COVERSHEET

Planned document changes:

EC226 QSM - ss10 Hoses

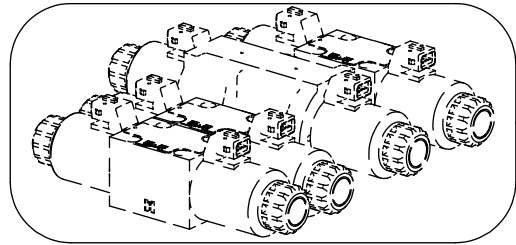
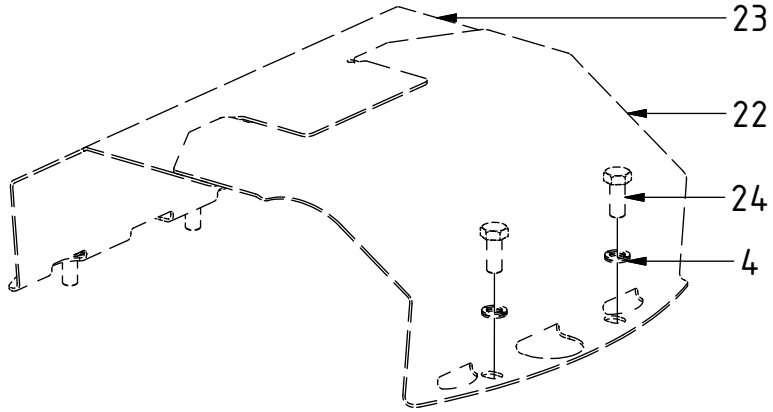
Add to POS.5: Torque: 79Nm.
Add to POS.7: Torque: 120Nm.

Top EC-Oil
(Not for 2Bl.Feed)

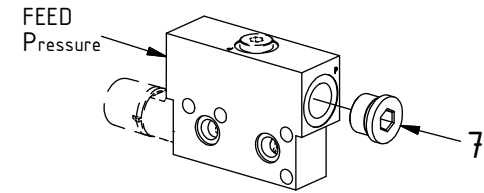
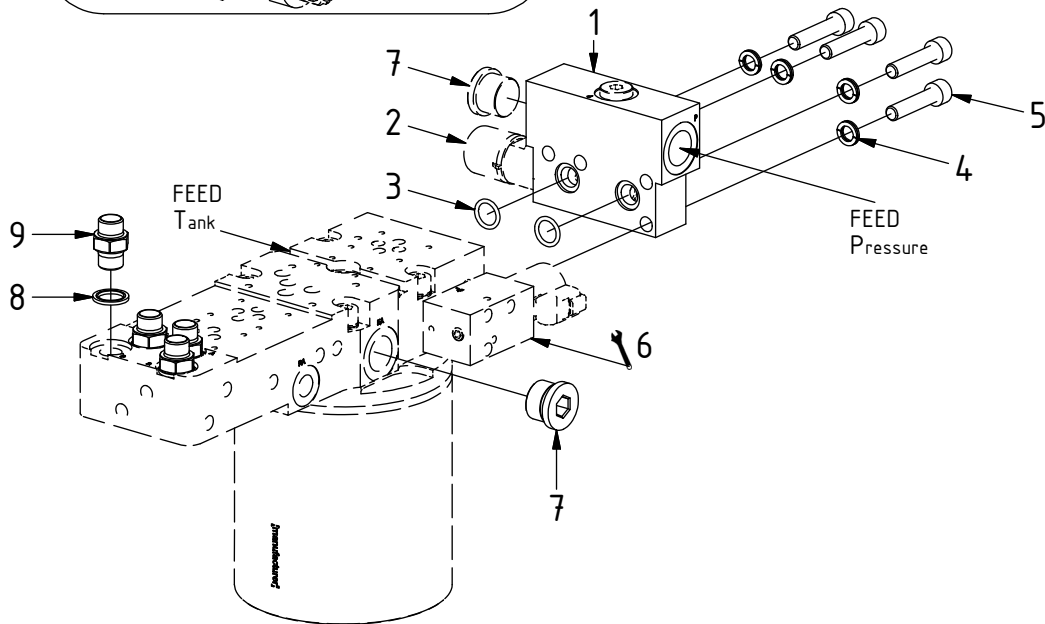
EC226R:
 27
 Replaces
 POS.8-9

Related spare parts

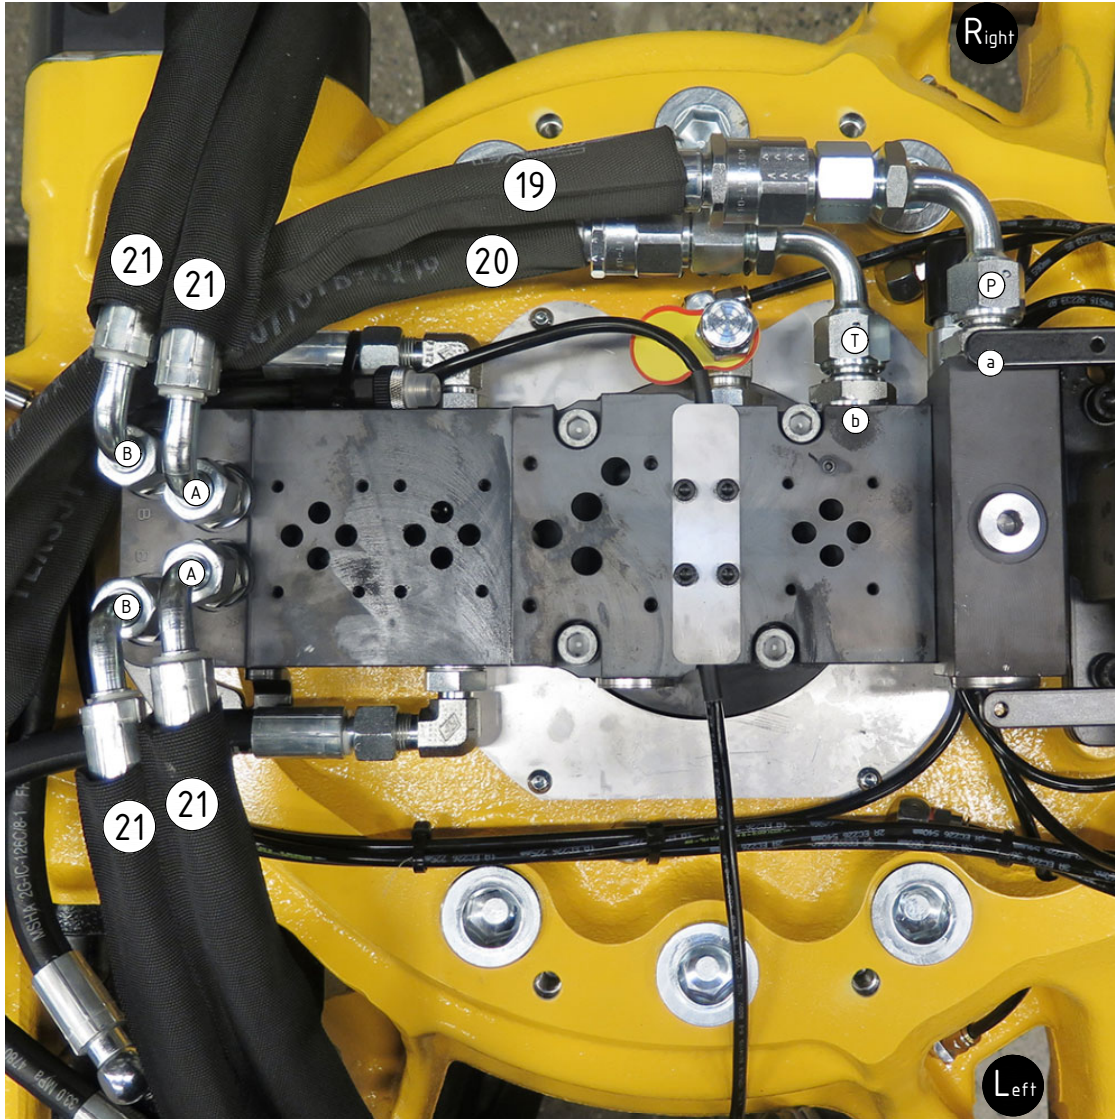
POS	DESCRIPTION	PART	QTY	COMMENTS
19	Hose Feed EC-Oil P	7001301	1	
20	Hose Feed EC-Oil T	7001302	1	
25	Hose Feed EC-Oil Short	74.2653	1	Replaced by POS.19 from 2020-01
26	Hose Feed EC-Oil Long	7000375	1	Replaced by POS.20 from 2020-01
